**To:** Kristopher Byrd, Well Construction Section Manager  
**From:** Tommy Laird, Well Construction Program Coordinator  
**Subject:** Review of Water Right Application G-19309  
**Date:** June 8, 2023

Application # G- 19309

GW Reviewer Phillip I. Marcy Date Review Completed: 04/18/2023

This Interference Analysis

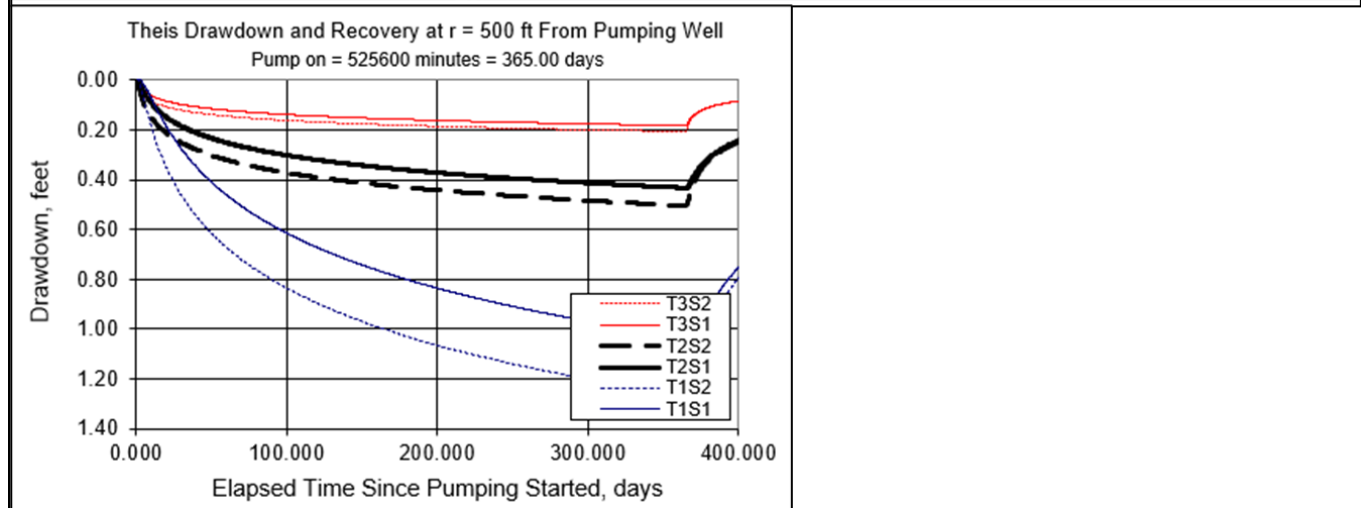
The proposed pumping rate of 0.03 CFS (13.46 GPM) is unlikely to cause excessive drawdown in any neighboring well that fully penetrates the alluvial aquifer. Considering that the existing POA well (Well 1) penetrates 20' of saturated gravel aquifer, and conditions appear to be unconfined at this location, a Theis calculation of drawdown at 500' from this well predicts less than 1.40' after 365 days of continuous pumping, using a range of conductivity values widely accepted for gravels.

**Stream Depletion (Hunt) Model Analysis**

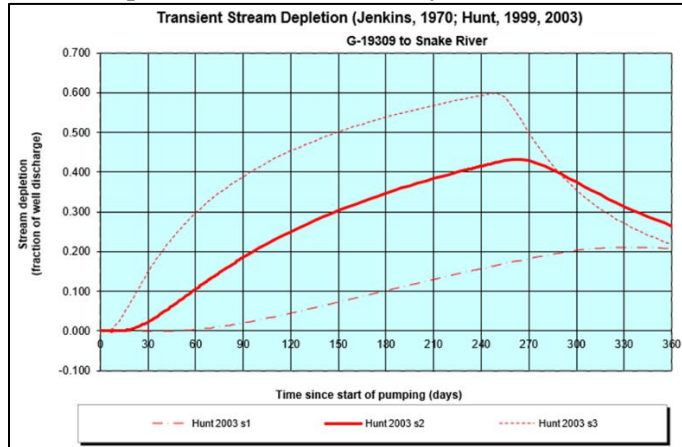
**Comments:** The proposed POA well lies greater than ¼ mile from nearby surface water sources and is anticipated to have less than 25% of groundwater pumped resulting from depletion of surface water after 30 days of continuous pumping. Using model parameters from the interference assessment in section B in the model of Hunt (1999), which includes a thin streambed clogging layer, it is anticipated that stream depletion will account for 18.6% of groundwater pumped after 30 days.
